City of Port Phillip
Advertised Plan 1 of 40

28-32 ALBERT ROAD, SOUTH MELBOURNE
DRAWING LIST

AMENDMENTS TO ENDORSEMENT PLANS:

Project Title
28-32 ALBERT ROAD
SOUTH MELBOURNE

Drawing Title
GENERAL ARRANGEMENT PLAN
LEVEL 06

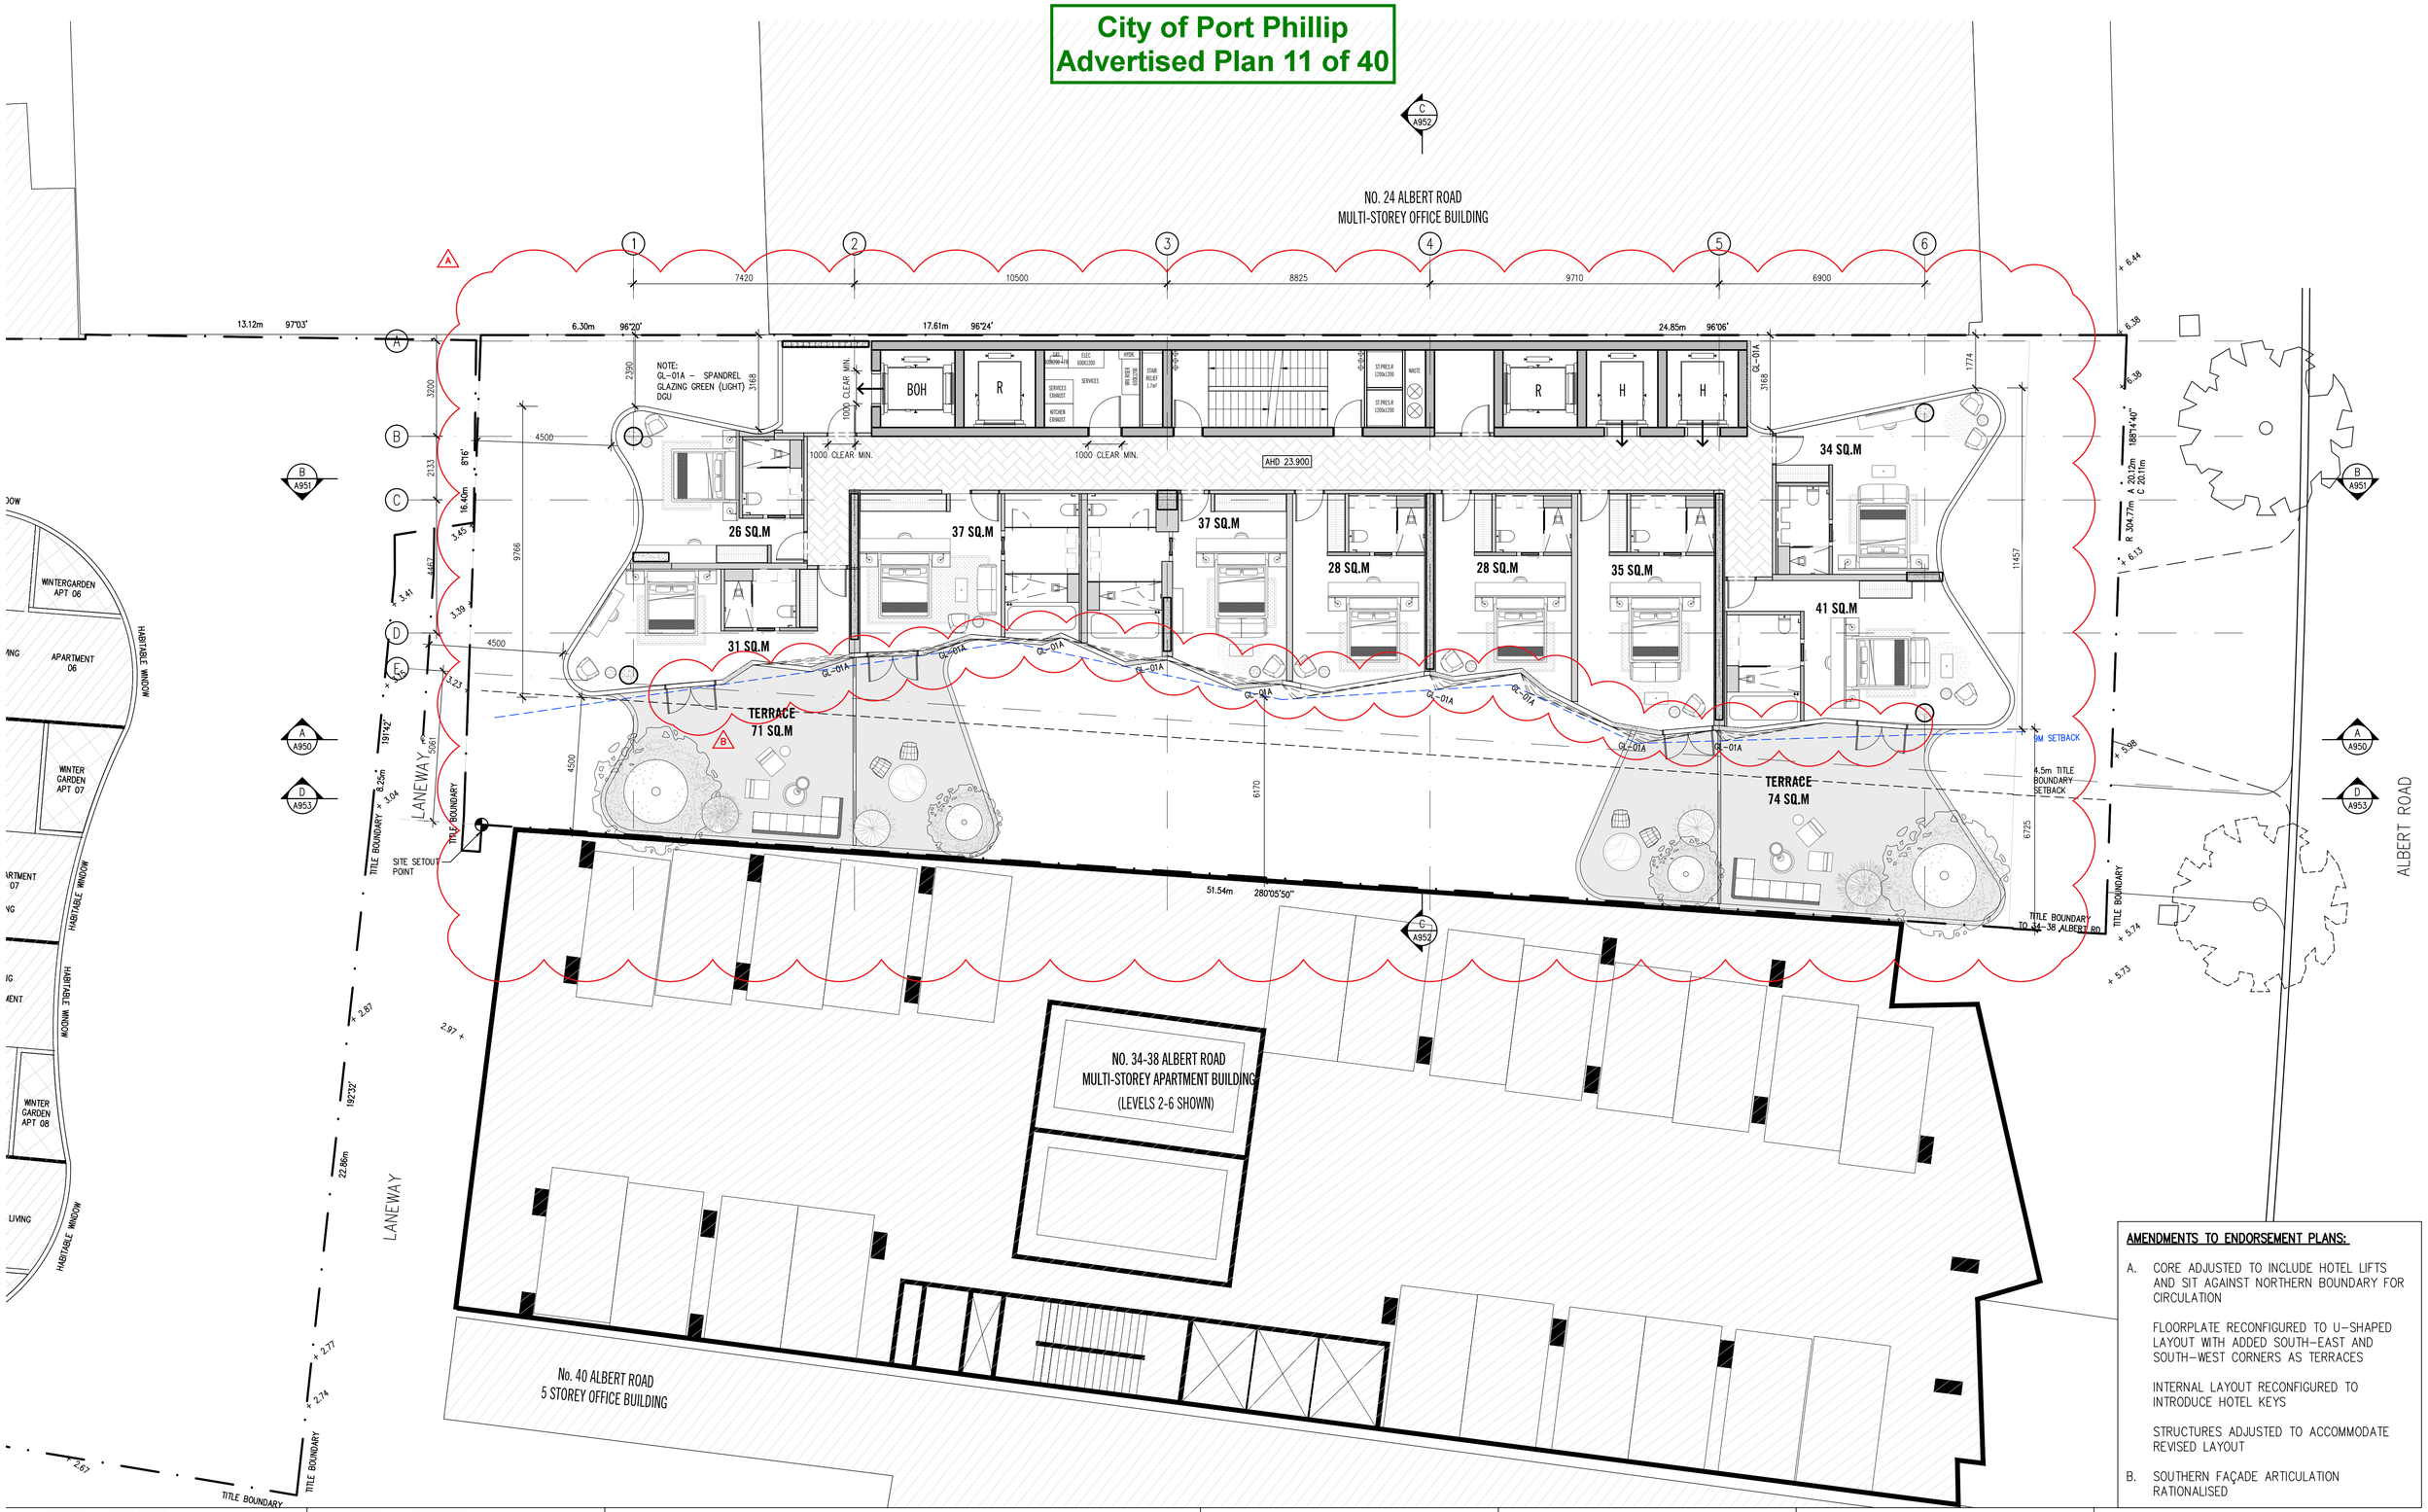
A. CORE ADJUSTED TO INCLUDE HOTEL LIFTS AND SIT AGAINST NORTHERN BOUNDARY FOR CIRCULATION

FLOORPLATE RECONFIGURED TO U-SHAPED LAYOUT WITH ADDED SOUTH-EAST AND SOUTH-WEST CORNERS AS TERRACES

STRUCTURES ADJUSTED TO ACCOMMODATE REVISED LAYOUT

Drawing Title
GENERAL ARRANGEMENT PLAN
LEVEL 10

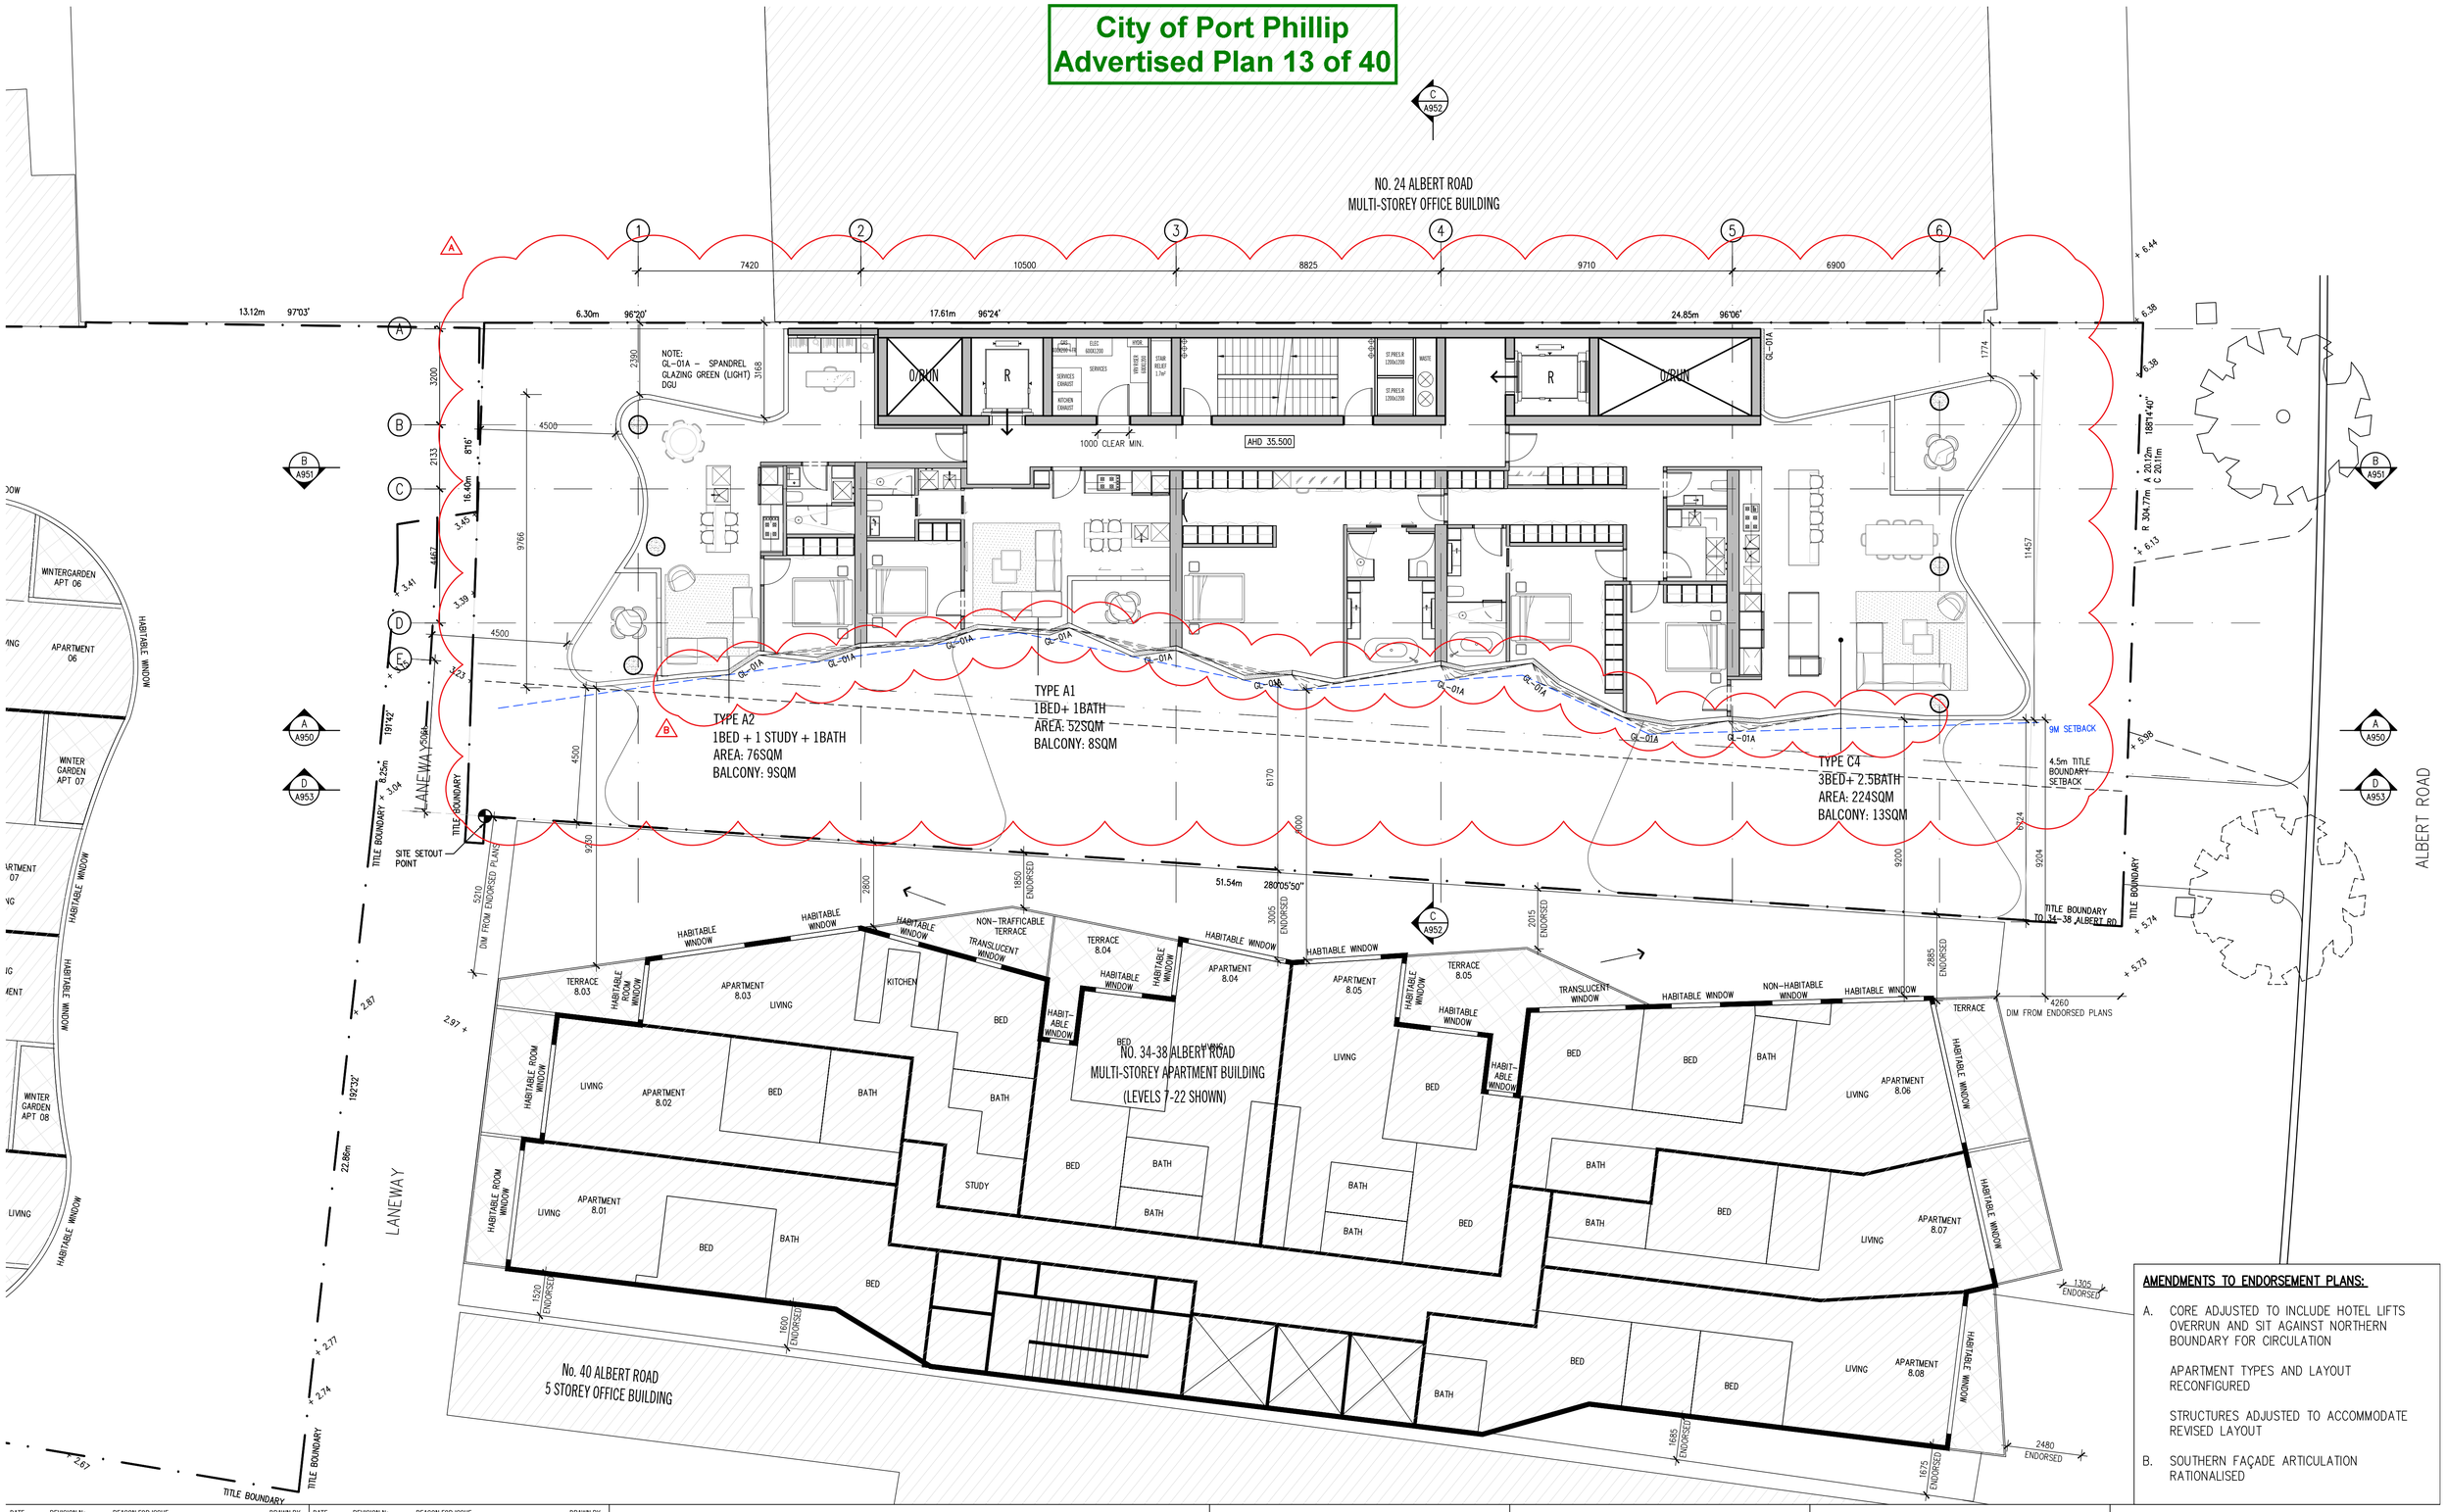
A. CORE ADJUSTED TO INCLUDE HOTEL LIFTS OVERRUN AND SIT AGAINST NORTHERN BOUNDARY FOR CIRCULATION

STRUCTURES ADJUSTED TO ACCOMMODATE REVISED LAYOUT

Drawing Title
GENERAL ARRANGEMENT PLAN
LEVEL 11 - LEVEL 14

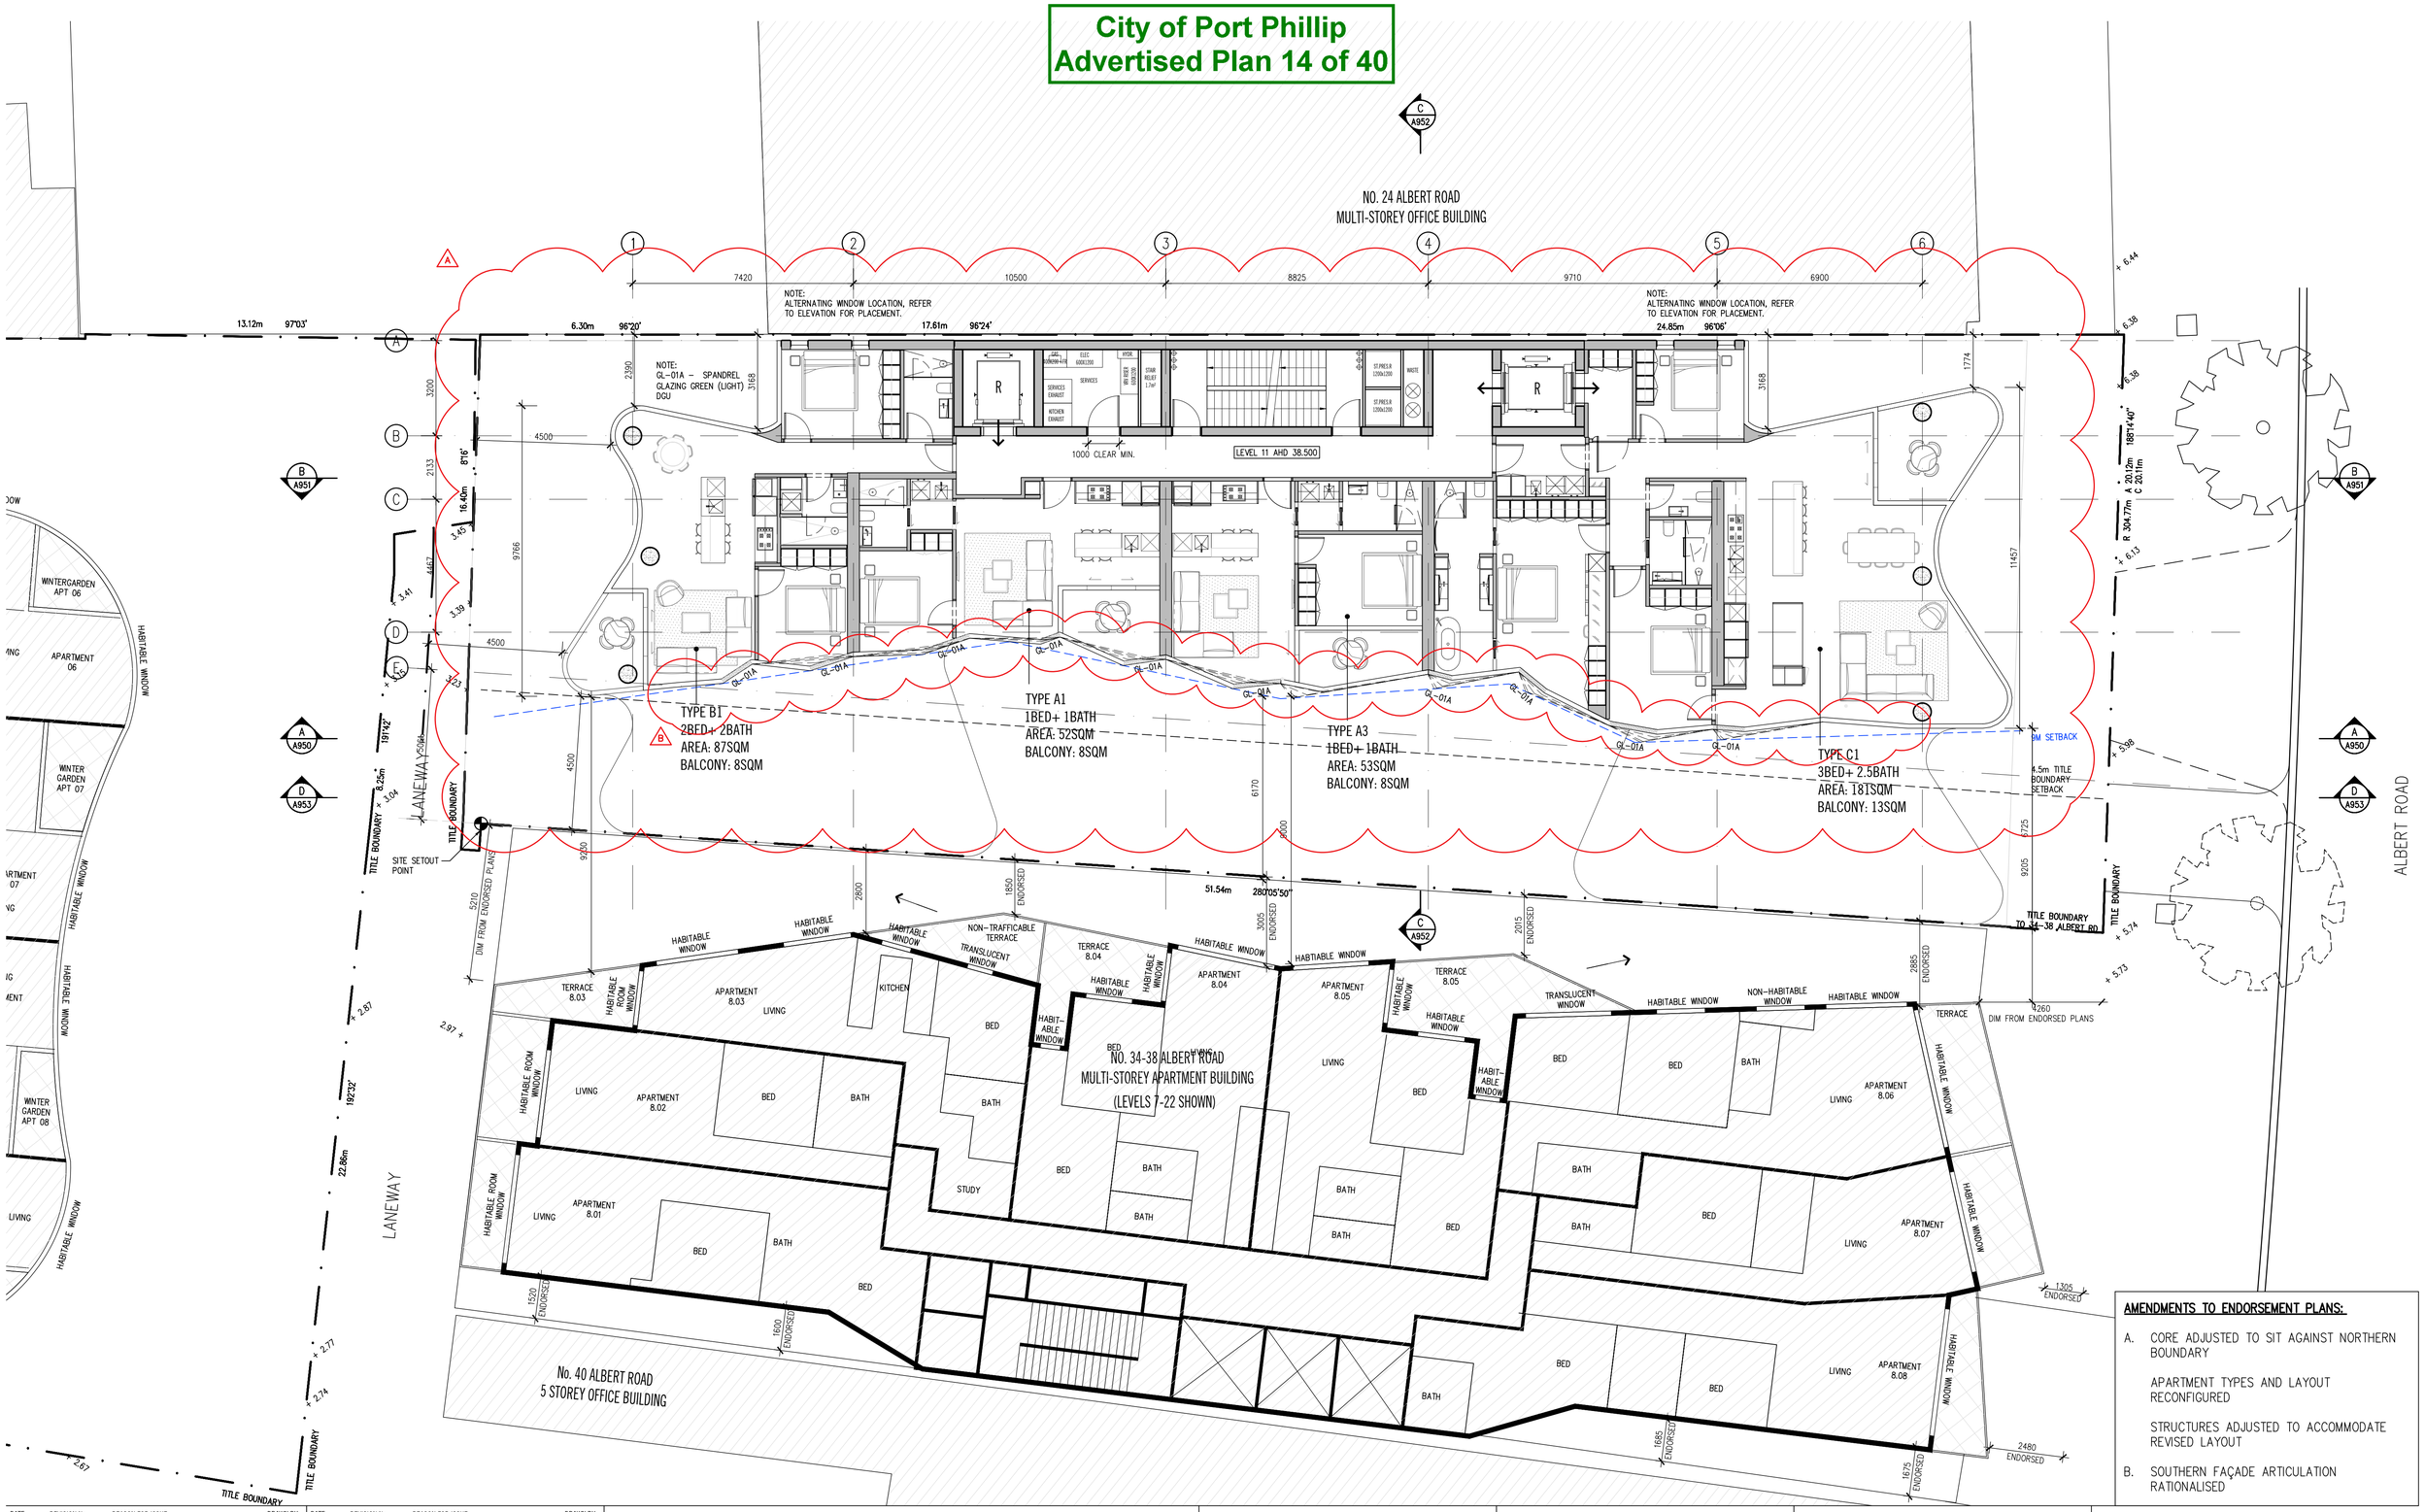
A. CORE ADJUSTED TO SIT AGAINST NORTHERN BOUNDARY

STRUCTURES ADJUSTED TO ACCOMMODATE REVISED LAYOUT
